Tech Tip

From your friends at New York Bus Sales

Product Effectuated – New D3 All American and Vision with the Updated Driver’s Compartment

FIGURE #1

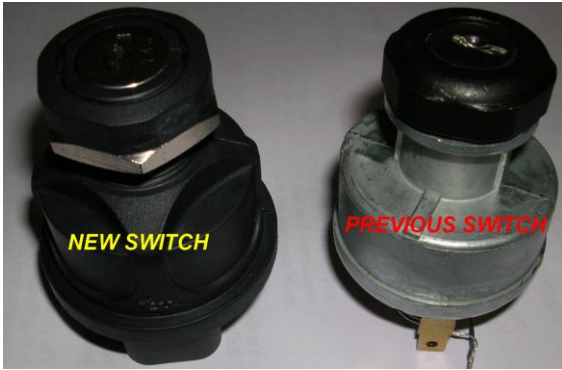
- Complaint -** **The ignition key is different!**
- We ordered “Keyed Alike” and it does not fit our other units.
 - We took the key to our local person who makes keys and they did not have a blank to cut

- Cause –** **Blue Bird Listened!** we had heard that the previous ignition key was sometimes cumbersome to use especially on those cold dark mornings and we took those concerns to Blue Bird who incorporated a new ignition switch into the updated steering column used in the new D3 and when they redesigned the driver’s cockpit in the Vision – This key slides easily in and out of the ignition switch and will work in either “direction” so to speak. Both switches are shown in Figure #1.

- The unfortunate part is that it is change and the new style cannot be used in previous models nor can the previous style cannot be used in the new model.

- We have actually taken both to a locksmith to see if tumblers could be changed but they are different also-
- Correction –** **Moving forward you will have the new easier to use switch and keys in your units –**

- To deal with the issue of blanks, we stock part #10012568 which is the key blank for the new switch. You can also use a “Club” key blank which I’m told is common and that is a #CLB8 and should be available where you have keys cut or your local locksmith

INFORMATION
 New Switch Part #10006548
 Old Switch Part # 00119994
